# **Five-Year Review Report**

Fourth Five-Year Review Report for

Lockheed Martin Corporation The Dalles Facility

Covering January 2005 through December 2012

Figure 3. Monthly CERCLA Landfill Leachate Production vs. Precipitation

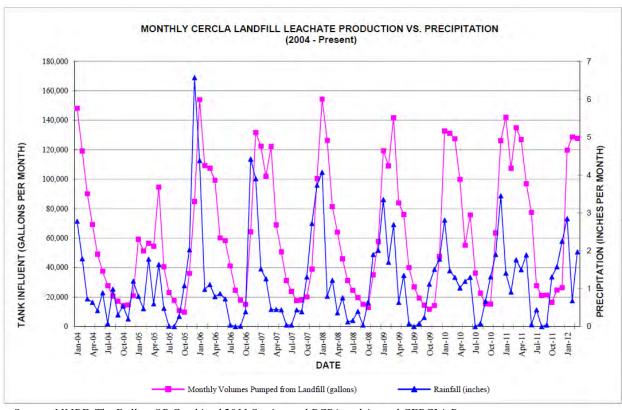
Leachate production has not decreased over time; furthermore, it is strongly correlated with precipitation as shown in Figure 3. The data in Figure 3 suggests that the majority of water produced by the LCS is shallow groundwater and stormwater infiltrating at the landfill perimeter. Because the landfill is not lined at the bottom, these sources of water will contribute to the LCS indefinitely. Average production rates are about 66,000 gallons per month, but can range up to 300,000 gallons per month during the rainy periods from December to March. Under the current LCS configuration and operating parameters, the volume of water being collected and treated is not expected to diminish.

Figure 5. WAD Cyanide Concentrations at CERCLA S Aquifer from 1989 to 2012

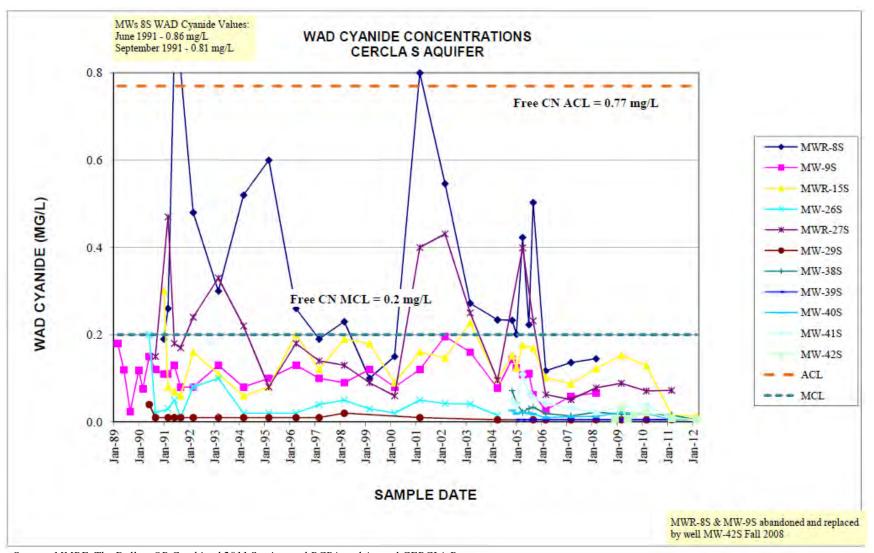
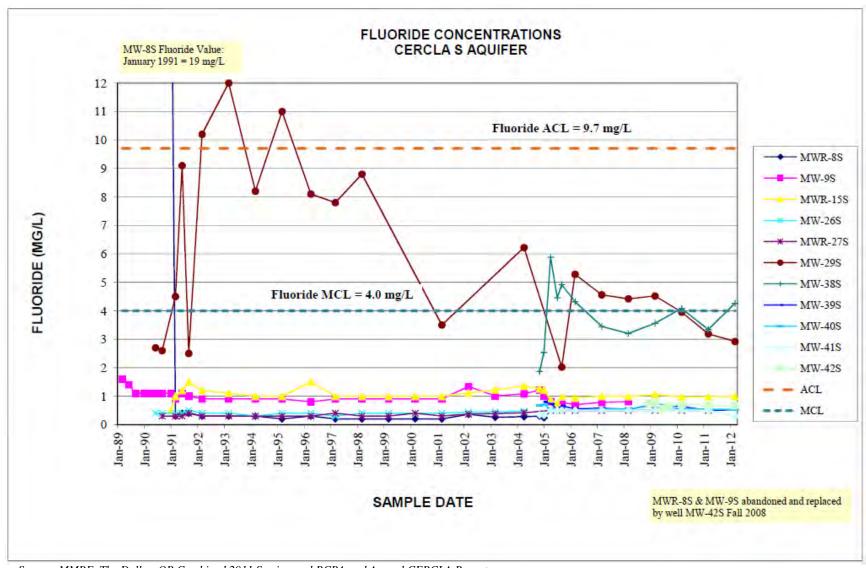
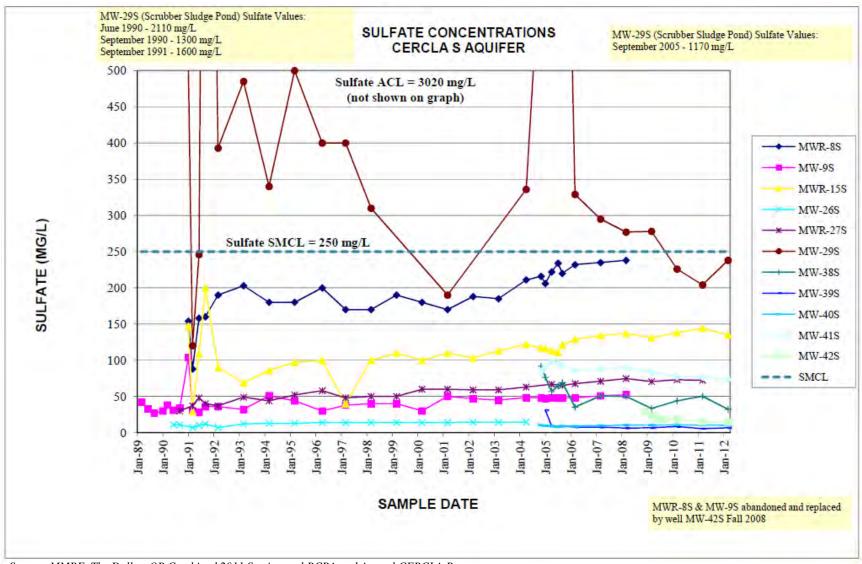
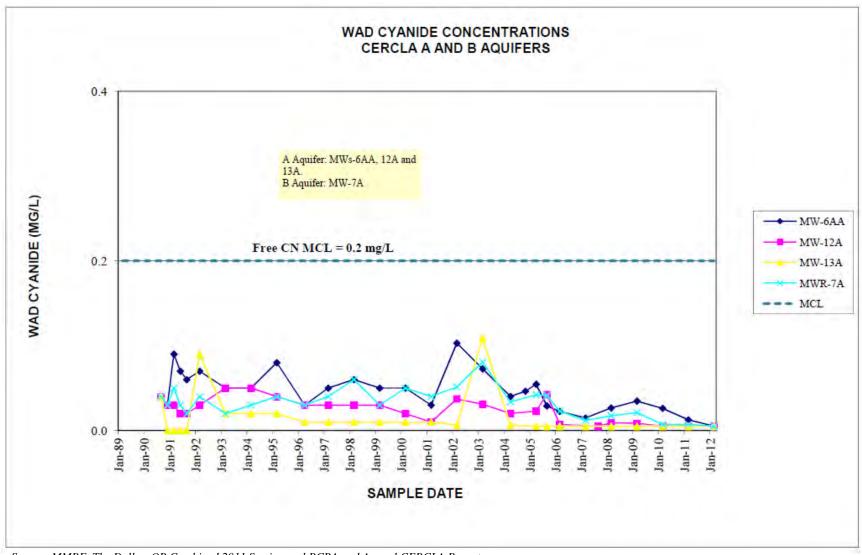
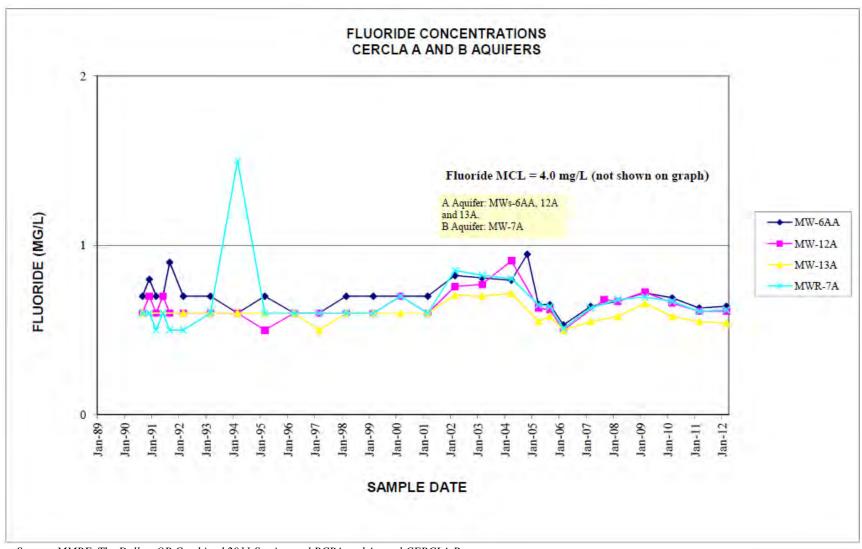
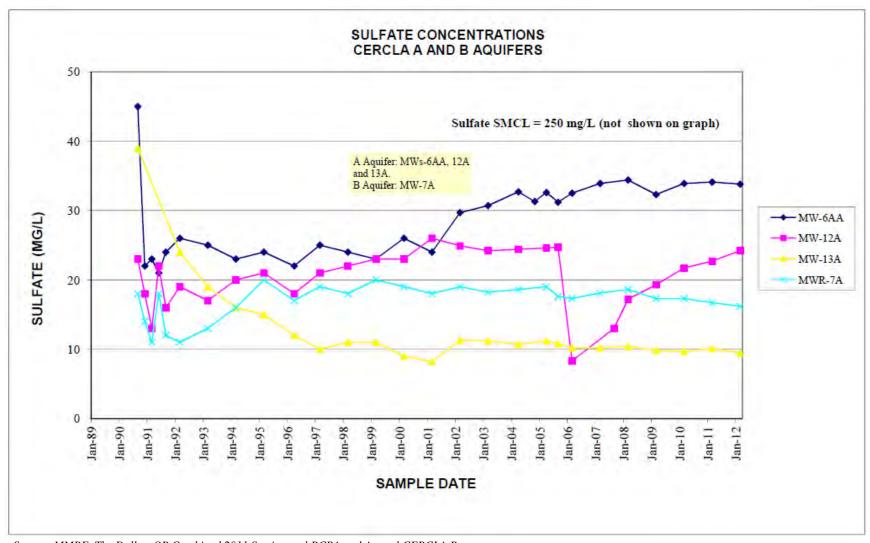
Monitoring results from wells in the S aquifer show that WAD cyanide has been below the 0.2 mg/L MCL since 2006. Well MW-29S historically had fluoride above the 4 mg/L MCL and continued to be slightly over the MCL from 2006 to 2010. Since 2010, fluoride levels in MW-29S have decreased to below the 4 mg/L MCL. Fluoride levels in MW-38S have also exceeded the MCL since 2005 and levels continue to fluctuate around the MCL value. No monitoring results from the other wells were above the MCL.

The limited groundwater monitoring data indicates that groundwater quality is static. There is no clear indication of significant impacts from the CERCLA landfill leachate to the S or A aquifers. However, insufficient data exists to fully understand groundwater at the Site. A site-wide comprehensive groundwater investigation needs to be implemented to make data-supported assessments of the groundwater quality. No new groundwater supply wells have been drilled in the vicinity of the Site since the last five-year review.
